Subject: 10CFR21 Reporting of Defects and Non-Compliance -
Engine Systems, Inc. Report No. 10CFR21-0114, Rev. 0

Subcover Assembly, P/N 1A-7846

Report No. 10CFR21-0114

COMPONENT: Subcover Assembly, P/N 1A-7846

Figure 1: Outline Drawing of Subcover

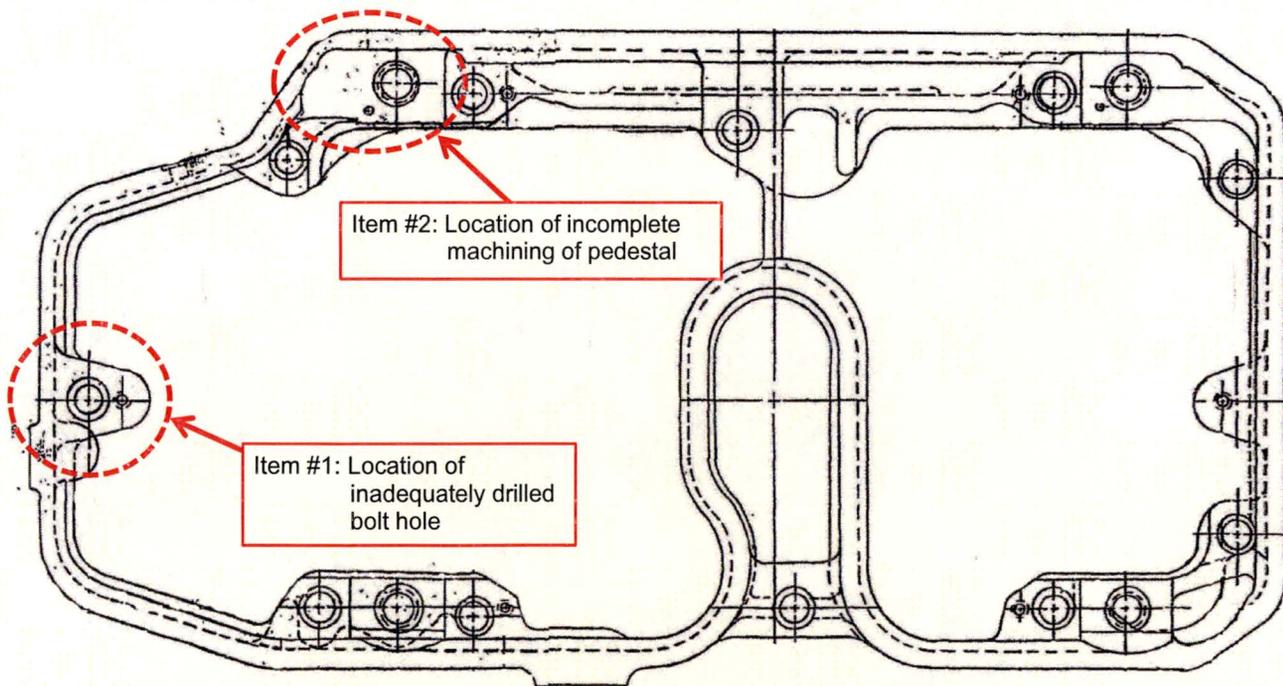
Engine Systems Inc. (ESI) began a 10CFR21 evaluation on November 18, 2016 upon notification of an issue with a subcover assembly at Perry Nuclear Plant. Attempts to install the subcover on their Enterprise diesel engine revealed two issues that prevented successful installation. First, one of the bolt holes was not fully machined through the entire depth of the subcover. Though the bolt could be inserted into the top of its corresponding hole, it would not pass completely through. The second issue was an interference between the rocker arm shaft and its mating pedestal. It was found that incomplete machining of the pedestal prevented the shaft from sitting flat on the pedestal.

Photo 2: Attempted Bolt Install

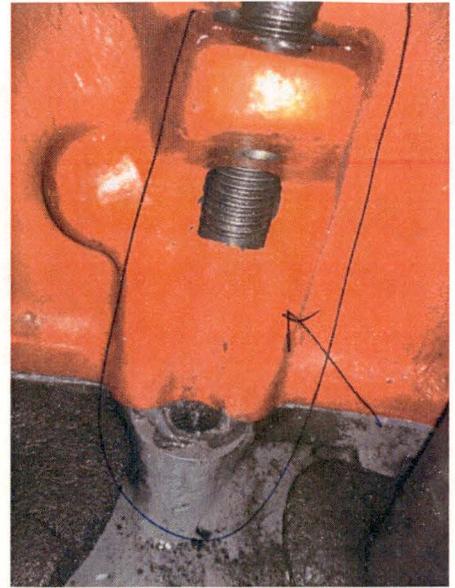
Item #1:

Photo 1: Visual Depiction of Inadequately Drilled Bolt Hole

The issue regarding the inadequately drilled bolt hole would be detected during installation since it would prevent the bolt from passing through the hole. Therefore, it is determined this issue would have no impact on operability since the cover could not be installed with an incompletely drilled bolt hole.

- a) Inspect for the bolt hole (item #1). If rework is necessary, drill through to a diameter of 13/16".
- b) For the incomplete machining of the rocker arm pedestal (item #2), first remove the installed dowel which has 0.000" to 0.001" clearance. Then machine a 2" radius relief at the affected area. All other dimensions such as pedestal height shall remain unchanged.

Figure 2: Ideal Pedestal Machining

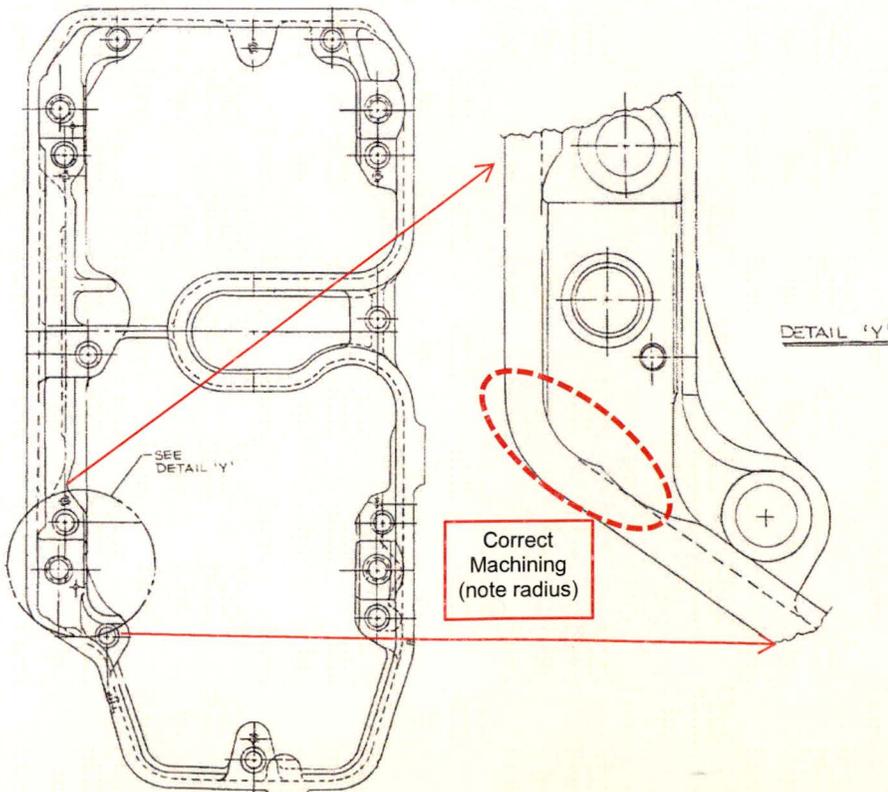
Item #2:

With regard to the incompletely machined pedestal, there is the potential that a customer could install the rocker arm shaft without detecting this issue. In this situation, the shaft will partially fit on the pedestal and the bolt will thread into subcover; however, the shaft will not seat fully on the pedestal. This prevents full contact with the pedestal and inhibits adequate preload throughout the bolted joint. If a customer were to install the rocker arm shaft (with mating rocker arms, pushrods, etc) onto the engine without realizing this issue, operability and durability of the engine would be compromised. This could present a substantial safety hazard.
